Bulletin Number: DTB-102414B

Date: 11/10/14
Product: DWB
From: Technical Support
Title: LP Conversion Adjustments

Fig. 1

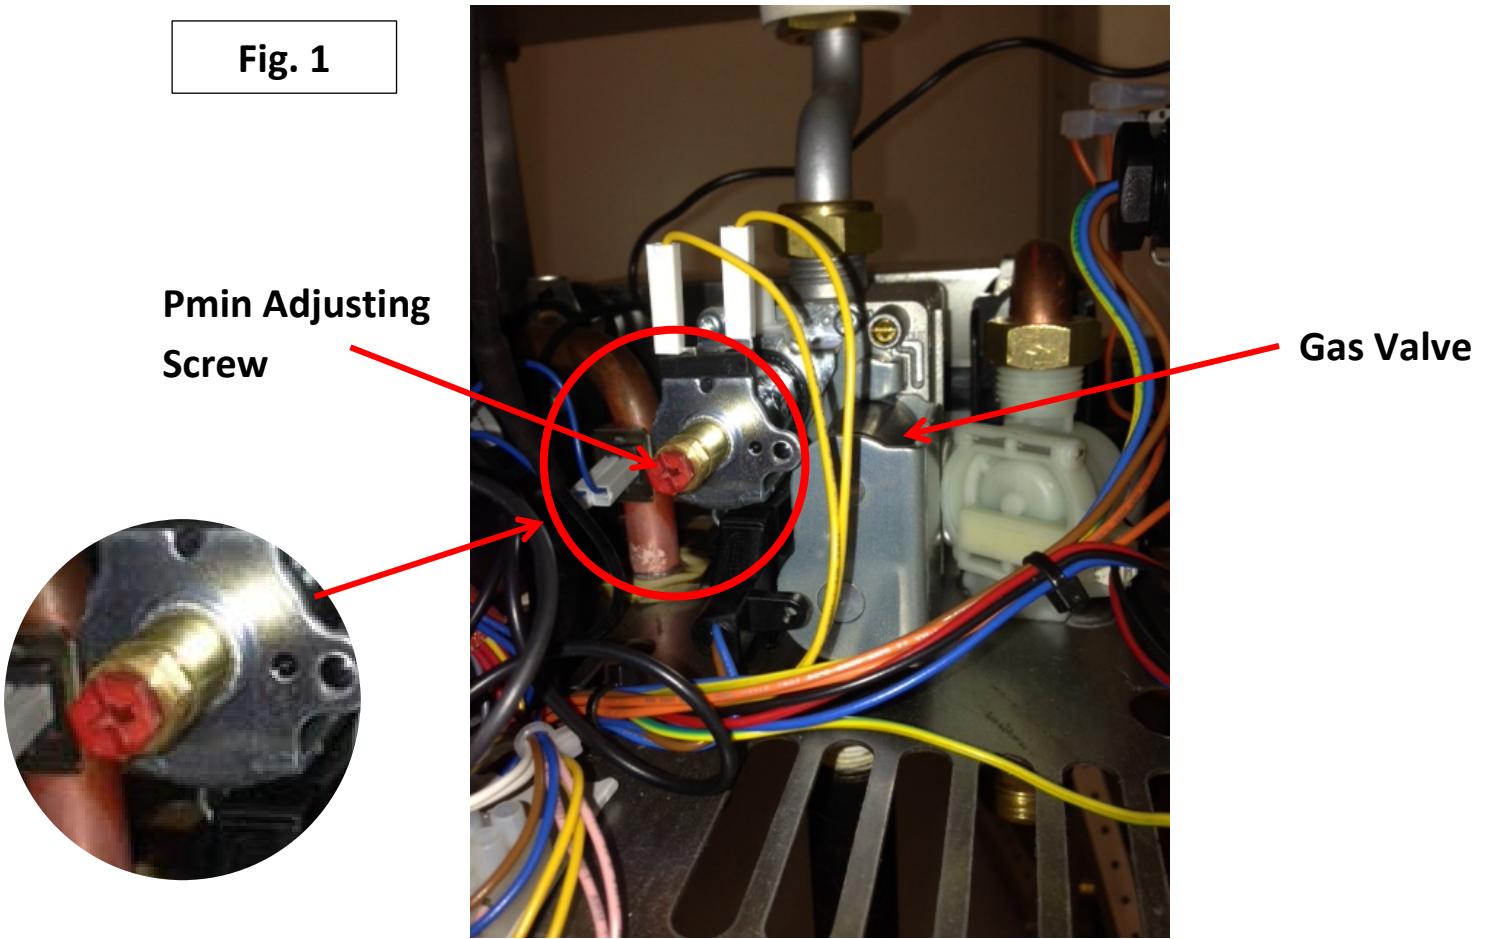
Because the Pmin is factory set for 0.15" w.c., when you disconnect the ModuReg valve to simulate Low Fire, the flame may decrease in size enough that you lose flame rectification. If this occurs, simply increase the Pmin setting by turning the Red screw on the gas valve clockwise 1/4 turn at a time until the boiler will sustain a flame at low fire, then set the manifold pressure according to the chart above for LP gas, see Fig 1. next page. Please refer to the LP Conversion Kit instructions for complete details.

LP Gas	CHB-100	CHB-130	CCB-150
Manifold Gas Pressure Maximum Input (Pmax)	10" w.c.	10" w.c.	10" w.c.
Manifold Gas Pressure Minimum Input (Pmin)	1.6" w.c.	1.6" w.c.	1.6" w.c.

After making these adjustments your CO₂ and CO readings should be confirmed.

CHB-130	CHB-130	CCB-150
	LP	LP	LP
CO ₂ at Pmax (%)	7.7 - 8.2	7.7 - 8.2	7.9 - 8.4
CO ₂ at Pmin (%)	4.4 - 5.1	4.4 - 5.1	4.8 - 5.5
CO at Max-Min	<400 ppm	<400 ppm	<400 ppm
